ECN/PCN No.: 4100

For Manufacturer		
Product Description: 4.7X4.1MM CERAMIC RESONATOR	Abracon Part Number / Part Series: AWSCR-MTD	<input type="checkbox"/> Documentation only <input checked="" type="checkbox"/> Series <input checked="" type="checkbox"/> ECN <input type="checkbox"/> Part Number <input type="checkbox"/> EOL
Affected Revision: I	New Revision: J	Application: <input type="checkbox"/> Safety <input checked="" type="checkbox"/> Non-Safety

4.7x4.1mm CERAMIC RESONATOR

AWSCR-MTD

Outline Dimensions

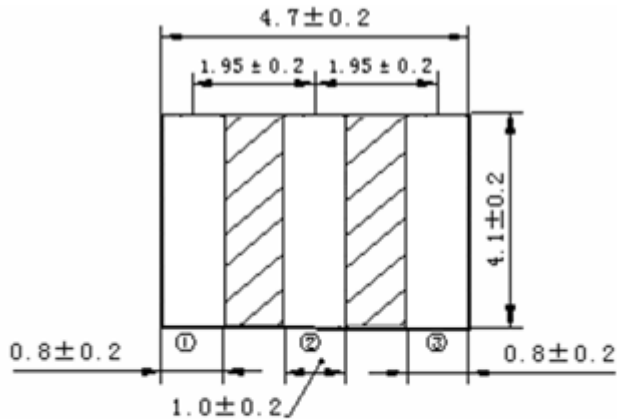
Prior to Change:
No height dimension included.

After Change:
Height dimension by frequency included:

Cause/Reason for Change:
Product height dimension should be included on the datasheet.

Frequency Range	Max Height (mm)
6.00 MHz - 13.00 MHz	1.70
13.01 MHz - 16.00 MHz	2.00
16.01 MHz - 25.99 MHz	1.80
26.00 MHz - 50.00 MHz	1.70

See Table 1
